**OFFICIAL COORDINATION REQUEST  
FOR NON-ROUTINE OPERATIONS AND MAINTENANCE**

**COORDINATION TITLE- 17TDA09 AWS Steel Frame**

**PROJECT- The Dalles Dam**

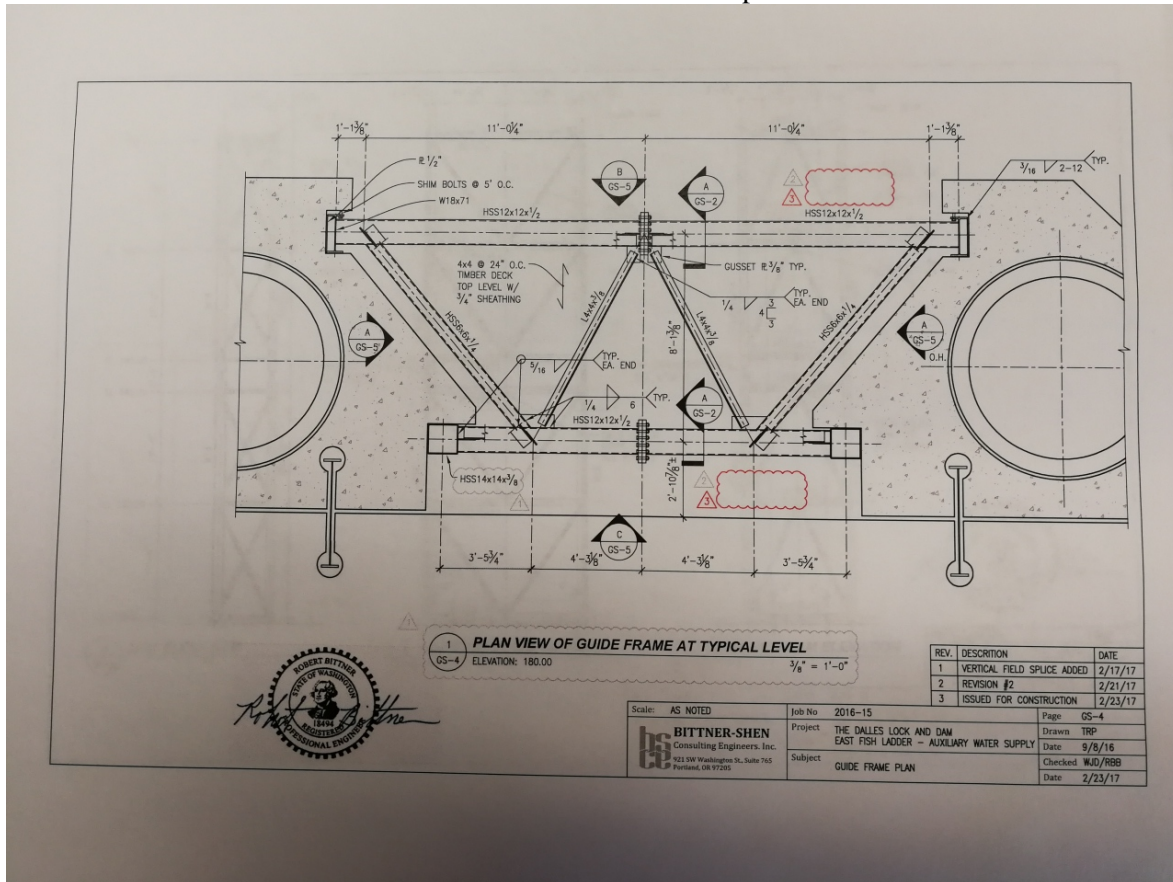
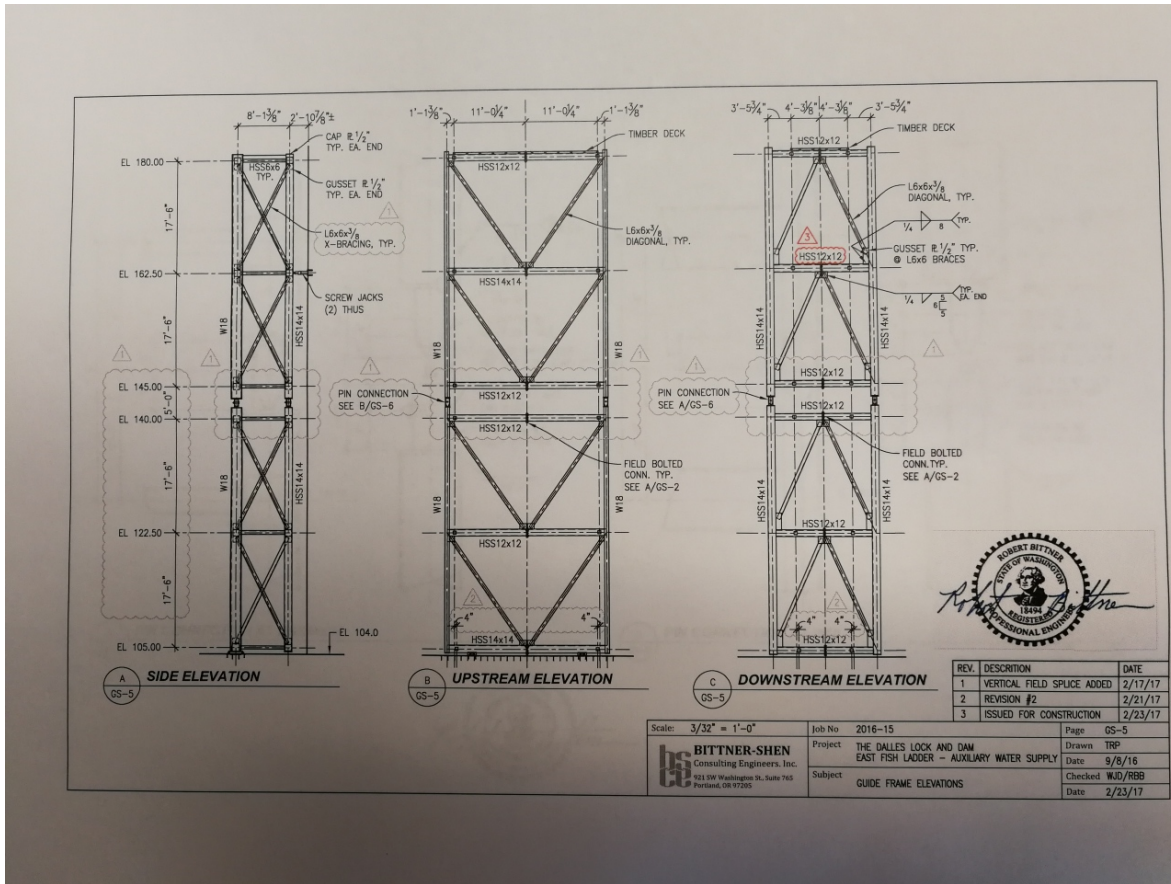
Erin/Bob, After thinking about this one for a bit and looking at the Plans and Specs, I can see that the footprint of this thing really isn't any larger than the finished intake, so no problems with having it in place all season. What concerns me is the work activity and proximity to the ladder exit. What I would like to see is more information regarding contaminants from the construction work (solvents, paint, curing agents, welding byproducts, etc.) that might be pulled into the fishway and possibly effect fish holding overnight in the ladder and collection channel. Thanks, Gary

looked this over at the meeting, seems with the work done at night should not pose a big issue.

**Final Results-** FPOM concurred with this action.
